**Subject:** #I Bilambee Lane, Bilgola Plateau DA 2020 1351 WRITTEN SUBMISSION:  
LETTER OF OBJECTION Submission: Sutherland

S U B M I S S I O N : S U T H E R L A N D  
a written submission by way of objection to DA 2020/1351

Re:  
#1 Bilambee Lane, Bilgola Plateau  
DA 2020 1351

*The demolition of existing structures and construction of a shop top housing development comprising two ground floor commercial premises and eight (8) residential apartments above, over two basement levels together with site works, drainage, landscaping and works within the road reserve, at No. 1 Bilambee Avenue, Bilgola Plateau.*

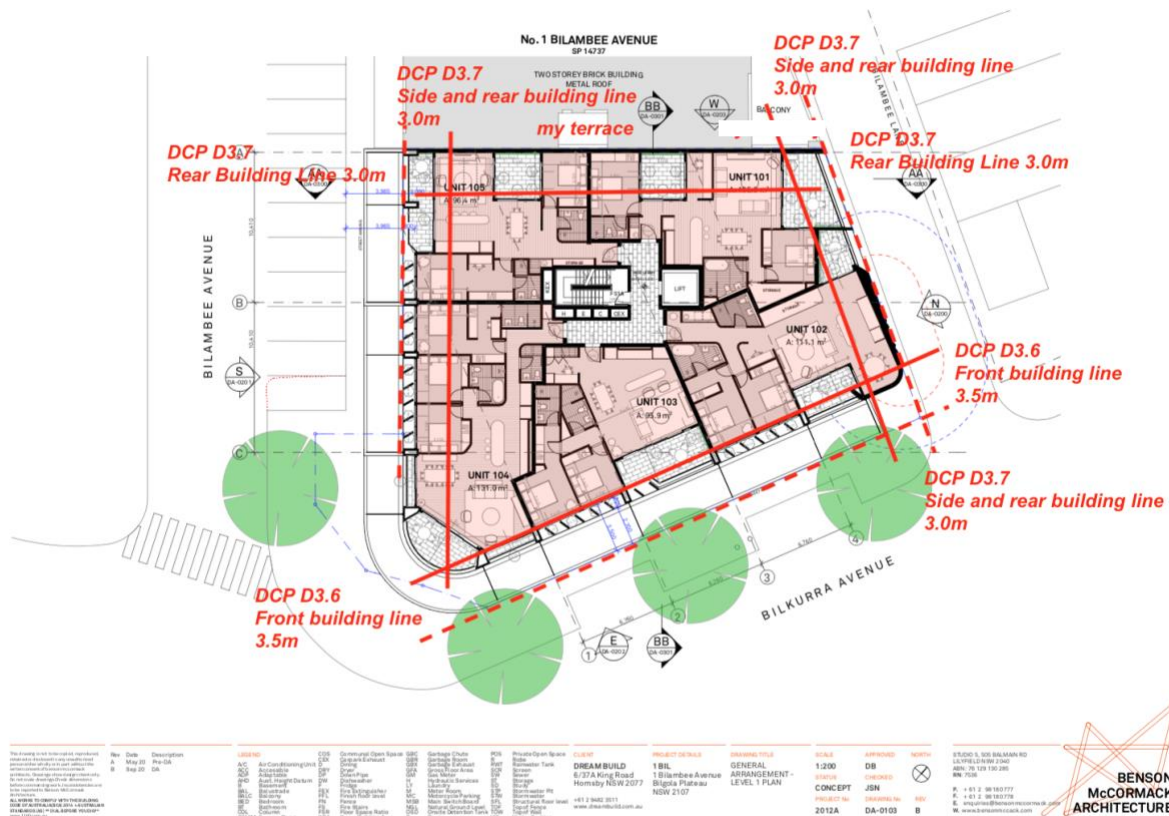
In this Submission I will identify the non-compliances to SEPP 65, LEP & DCP controls to show that the development is totally unreasonable and unacceptable.

I will propose a series of modifications to the proposed development to overcome the amenity issues for Council to consider. If the Developer does not submit Amended Plans to resolve these matters, I ask Council to immediately REFUSE the DA.

*Non Compliance to LEP 4.3 Building Height, LEP 4.5A Density Controls, DCP D3.7, DCP D3.9 and any new parapet not to exceed RL 147.1 to be positioned under the sill level of the Terrace facing the subject site.*

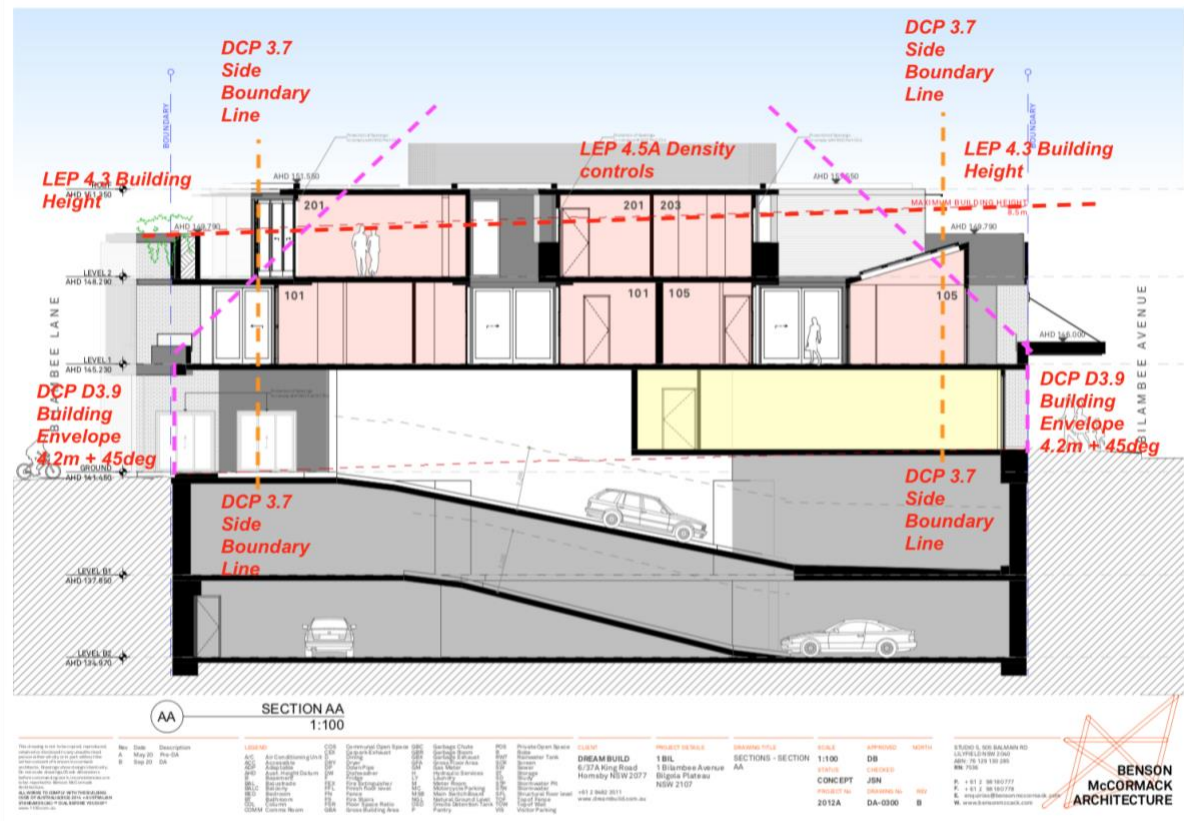
*I request full building envelope compliance facing Bilkurra Avenue and my property, with full compliance to building height, density controls, building envelope, and setback controls*

- Reduce wall height at street frontages to a maximum of RL 148.87 to match neighbours parapet and to reduce scale and bulk
- Delete all units at Level 2, and the roof to become non-trafficable
- Position roof plant centrally, and no higher than RL 150.0 [8.5m above contour 141.5]
- Building Height to reduce to 8.5m to LEP 4.3 Building Height
- Reduced number of Units to a maximum of 6 to comply with LEP 4.5A Density Controls
- Adherence to DCP D3.9 Building Envelope to 45 degree
- Adherence to DCP D3.6 Front building line to 3.5m
- Adherence to DCP D3.7 Side and rear building line to 3.0m
- Adherence to DCP C1.1 Landscaping to better screen proposed development
- New parapet not to exceed RL 147.1 to be positioned under the sill level of the Terrace facing the subject site.
- Privacy screens to residential units facing my property

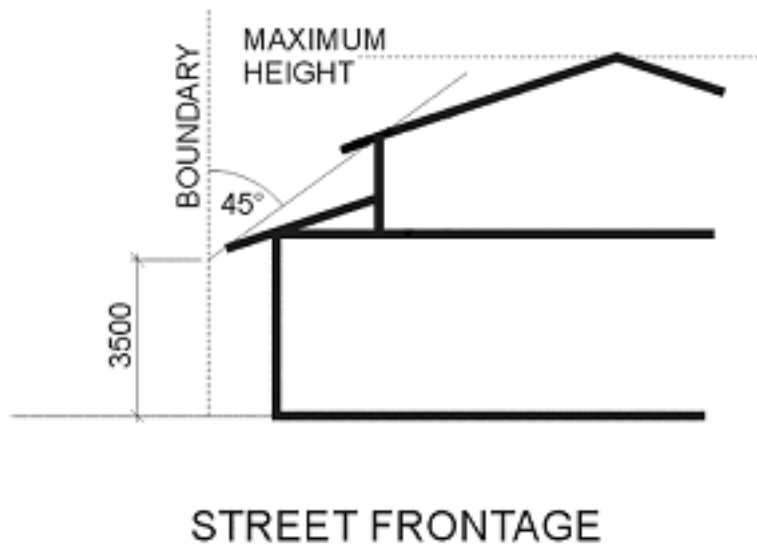
*The bulk and scale of the built form is minimised. (En, S)*

*Equitable preservation of views and vistas to and/or from public/private places. (S)*
